Illinois Department of Transportation

SUBJECT: Lewis University Airport (LOT)
Romeoville, Illinois
Will County
Illinois Project Number: LOT-4619
SBG Project Number: 3-17-SBGP-144
Contract No. LE055
Item No. 02A, November 6, 2020 Letting
Addendum A

NOTICE TO PROSPECTIVE BIDDERS

CONSTRUCT ATCT ACCESS ROAD WITH UTILITIES

Drawing Title
TYPICAL SECTIONS AND PAVEMENT DETAILS

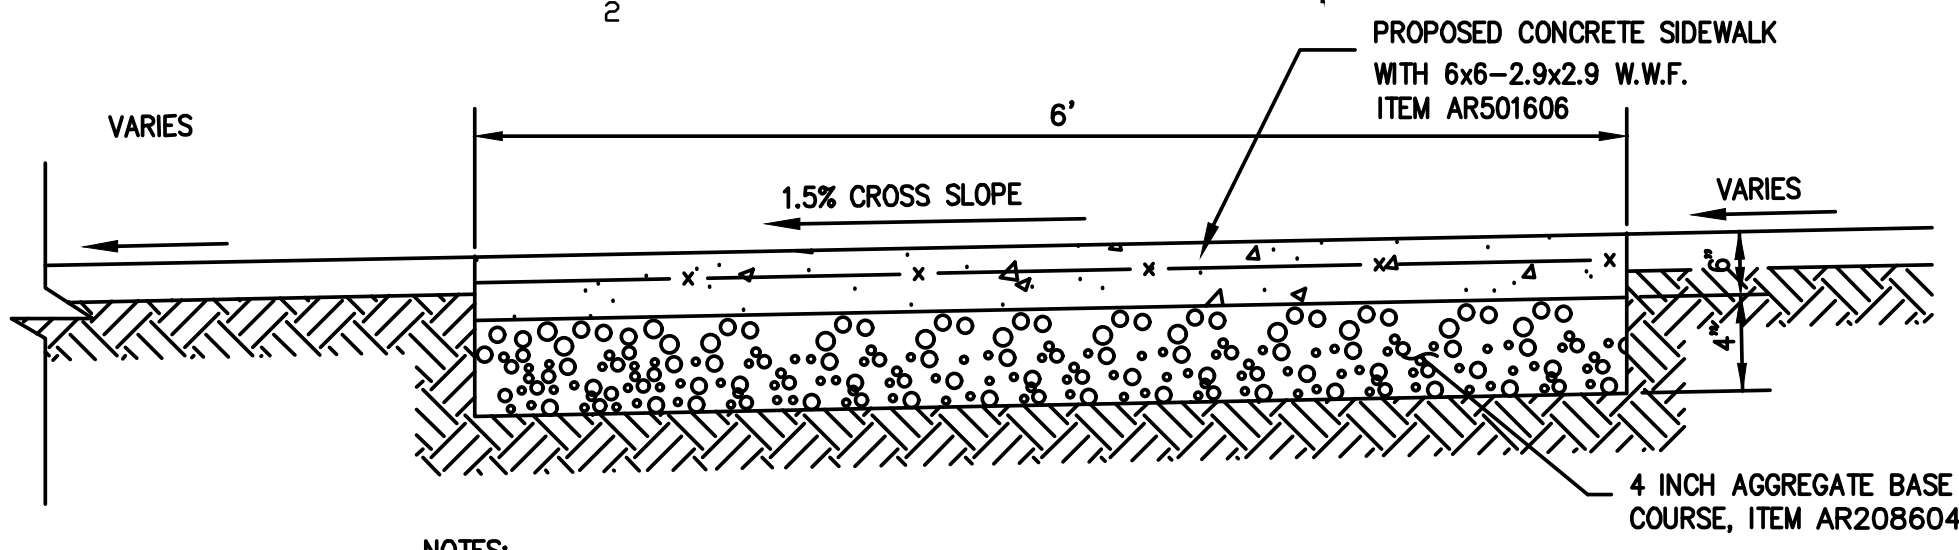
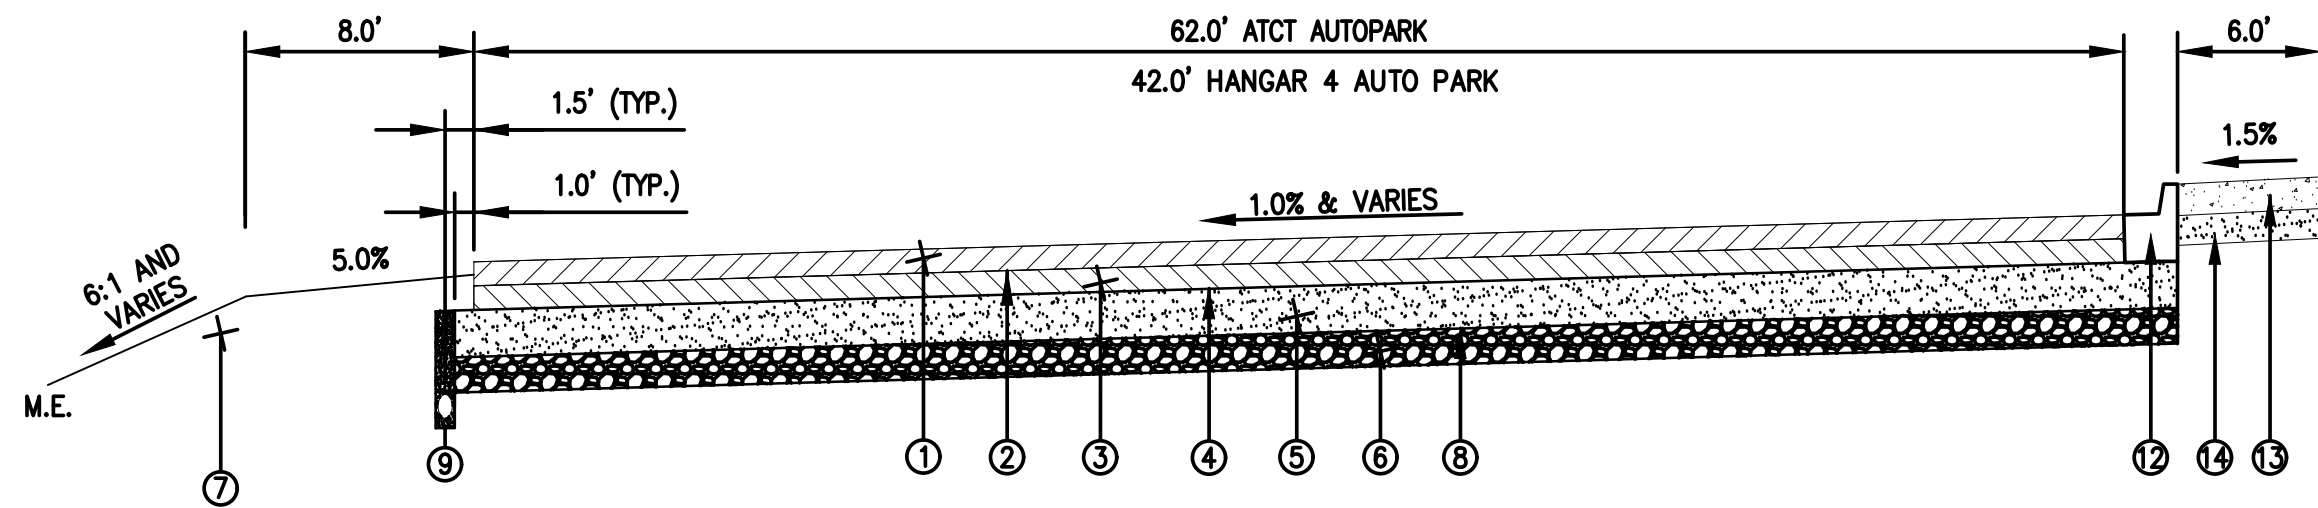
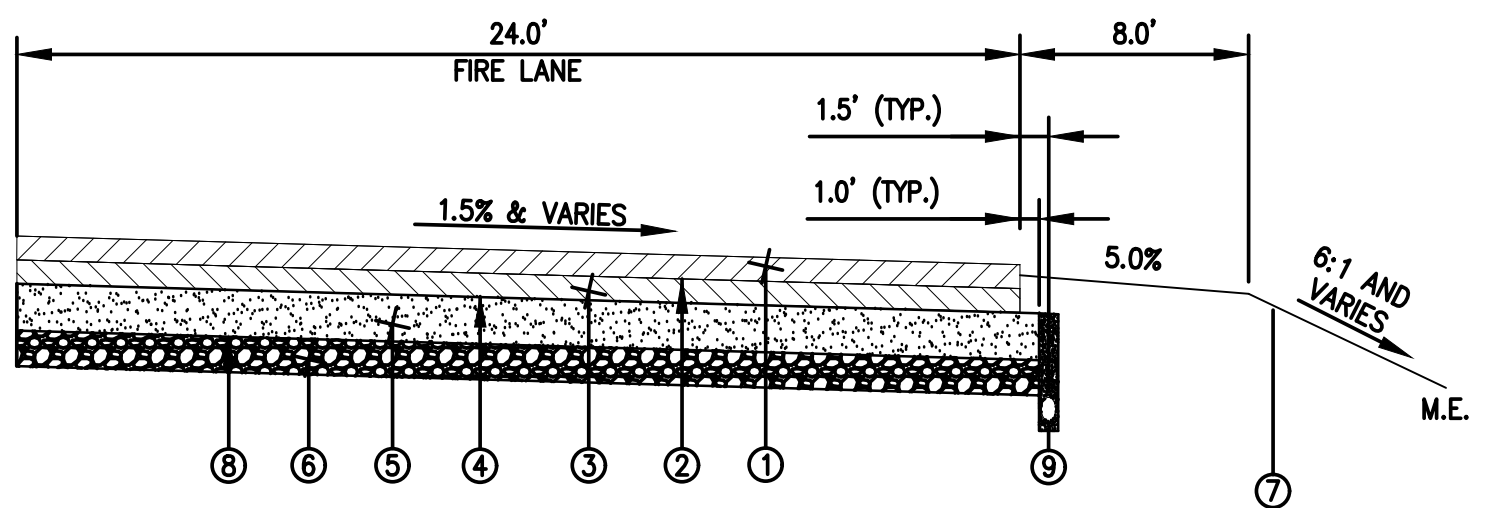
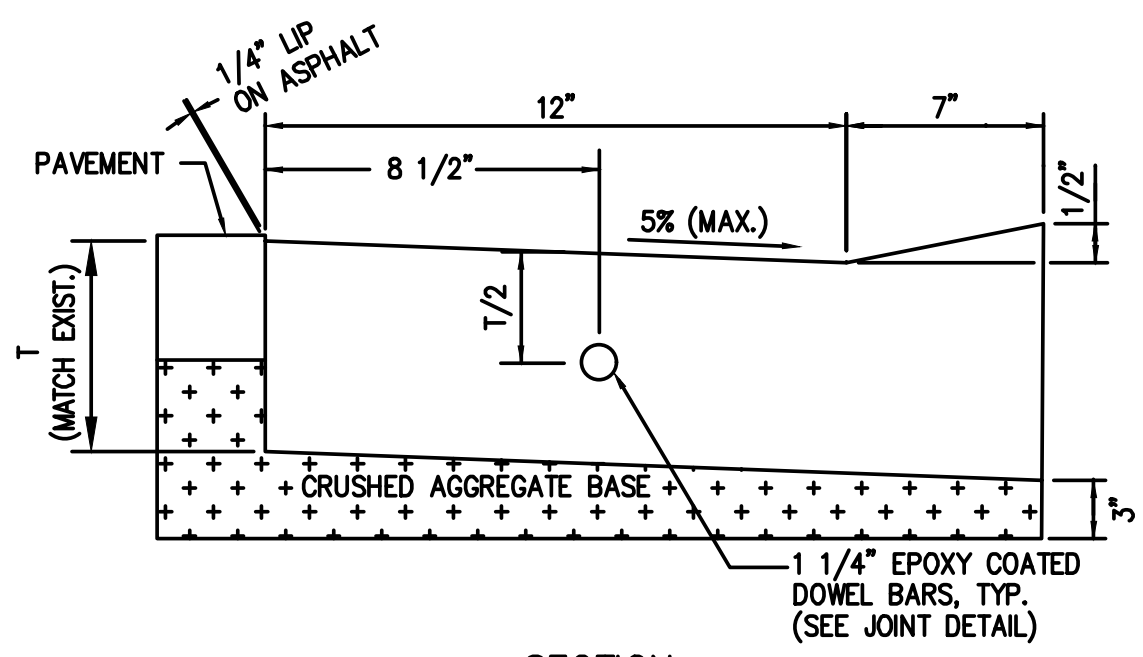
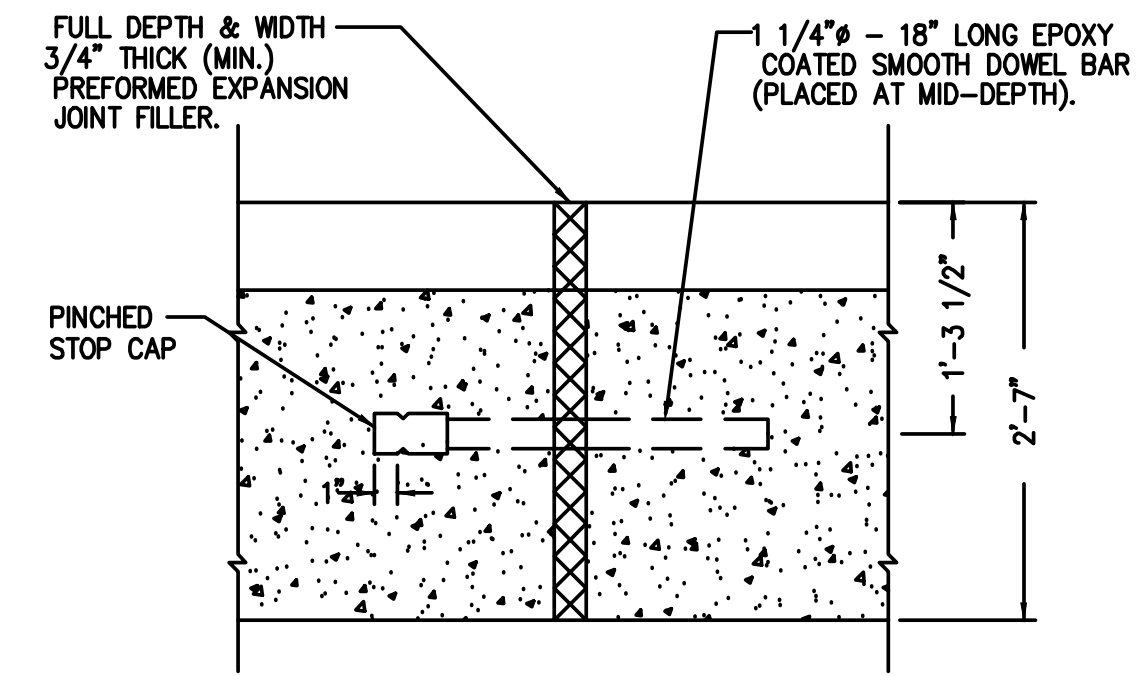
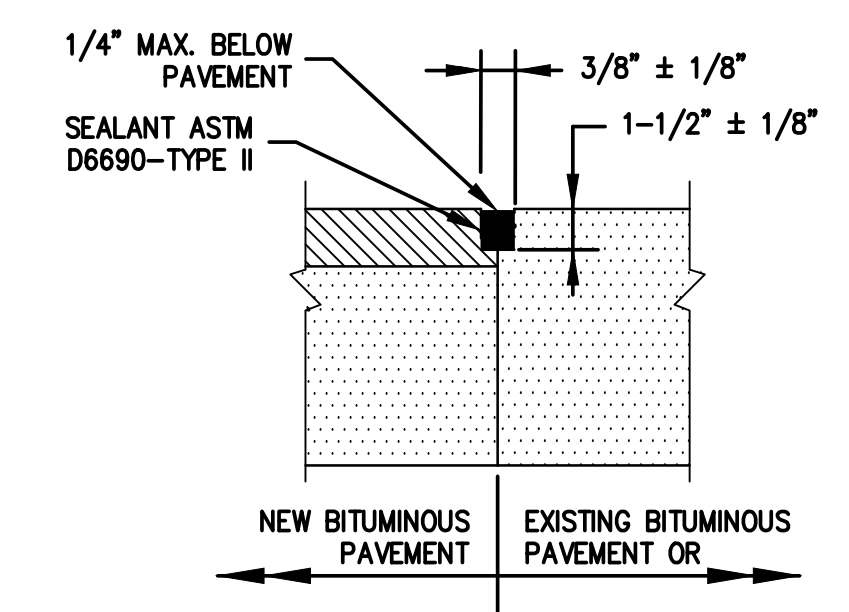
- 1) Correct the bid quantity for Item AR751412 Inlet Type B
- 2) Clarify the detailed thickness for AR209613 Crushed Agg. Base Course - 13"
- 3) Identify structure type for Structures S-103, S-104 and S-105 for Item AR751412 Inlet Type B

- 1) Drawing C1.0 Sheet Index and Summary of Quantities
- 2) Drawing C5.0 Typical Sections and Pavement Details
- 3) Drawing C11.1 Storm Sewer Schedules
